<b>Title - Sujet</b> Seawater System and Pumphouse Const	
<b>Solicitation No. - N° de l'invitation</b> EB144-190610/A	<b>Amendment No. - N° modif.</b> 004
<b>Client Reference No. - N° de référence du client</b> EB144-19-0610	<b>Date</b> 2018-08-03
<b>GETS Reference No. - N° de référence de SEAG</b> PW-\$PWA-104-5757	
<b>File No. - N° de dossier</b> PWA-8-80026 (104)	<b>CCC No./N° CCC - FMS No./N° VME</b>
<b>Solicitation Closes - L'invitation prend fin</b> <b>at - à 02:00 PM</b> <b>on - le 2018-08-09</b>	<b>Time Zone</b> <b>Fuseau horaire</b> Atlantic Daylight Saving Time ADT
<b>F.O.B. - F.A.B.</b> <b>Plant-Usine:</b> <input type="checkbox"/> <b>Destination:</b> <input checked="" type="checkbox"/> <b>Other-Autre:</b> <input type="checkbox"/>	
<b>Address Enquiries to: - Adresser toutes questions à:</b> Nowakowski, Leanne	<b>Buyer Id - Id de l'acheteur</b> pwa104
<b>Telephone No. - N° de téléphone</b> (902) 403-7112 ( )	<b>FAX No. - N° de FAX</b> (902) 496-5016

Amendment 004 is being issued to provide further questions and answers, as well as additional sketches, drawings and information that should form part of the submission.

12-E-SK001

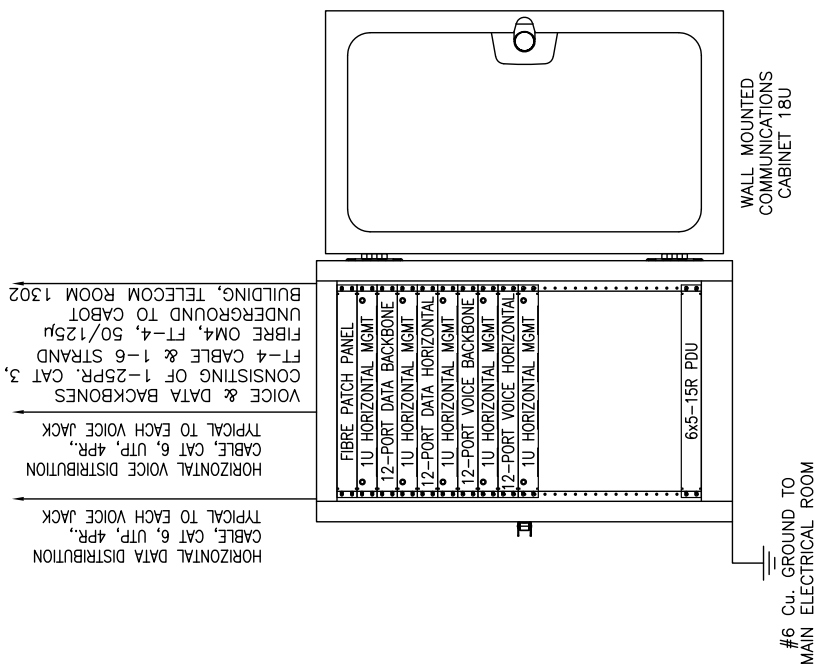
- .1 Revise the fire alarm annunciator shown to be a fire alarm panel (to match existing system throughout campus, Simplex 4100U) to support new devices and tie-in to existing campus system. Refer to riser on sketch 12-E-SK001.
- .2 Supply and install a wall mounted communications rack in Seawater Pumphouse c/w accessories as indicated on sketch 12-E-SK002.

1. INITIATION LOOP WIRING IS TO BE 2C#18 AWG CU. MINIMUM, AND IN ACCORDANCE WITH MANUFACTURERS REQUIREMENTS.
2. ANNUNCIATION LOOP WIRING IS TO BE 2C#14 AWG CU. + #12 CU. BOND, MINIMUM, AND IN ACCORDANCE WITH MANUFACTURERS REQUIREMENTS.
3. REMOTE FIRE ALARM PANEL WIRING IS TO BE 1PR. #14 CU. TWISTED SHIELDED + 1PR. #18 CU. TWISTED SHIELDED CABLE.
